The City of Spartanburg Design Review Board

1. DRB-25-020-00013 — The Design Review Board (DRB) has received a request for Full & Final Approval of the proposed development, Spartanburg Hudson Automotive Parking, located at 400 E Daniel Morgan Ave (Tax Map Sheet: 7-12-06-061.00) with a zoning designation of DT-5 (Downtown Urban Center). **Owner: RP CGR SBG MAZ-SUB; Applicant: Hudson Automotive Group**

PROJECT/ADDRESS/ TAX IDSpartanburg Hudson Automotive Parking / 400 E Daniel
Morgan Ave / 7-12-06-061.00**PROJECT NUMBER**

The existing Spartanburg Subaru dealership is proposing the addition of an accessory structure to serve as an auto detailing area, along with an expanded 126-space parking lot. The project also includes new landscaping and streetscape enhancements. This application is for Full and Final Review.

Option 1: Opaque Glass with Slate Base

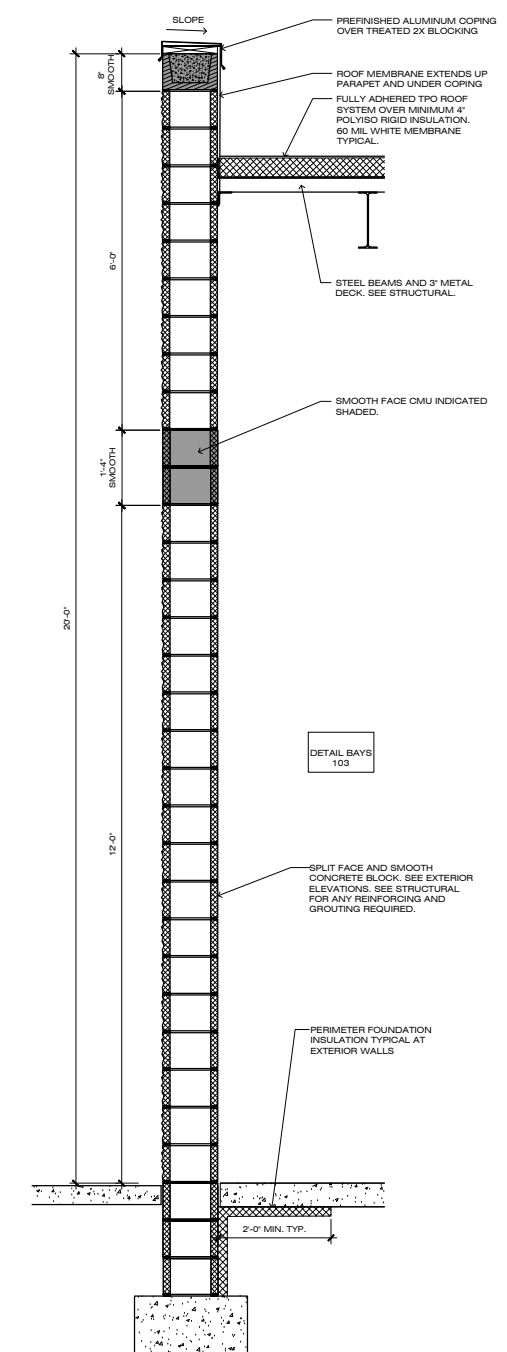
- Treatment for glass at the front of the building, including specifications for opacity or window film.
- Two material options for the water table, including one option using CMU and one option using the originally proposed slate finish.
- Material of the front-facing door, including the potential to relocate the door to the side of the equipment room. If relocation is not possible, the Board would like to see a glass shopfront door.

- **6.4.4 Ground Level Detailing:** More detail requested on opacity of front-facing windows
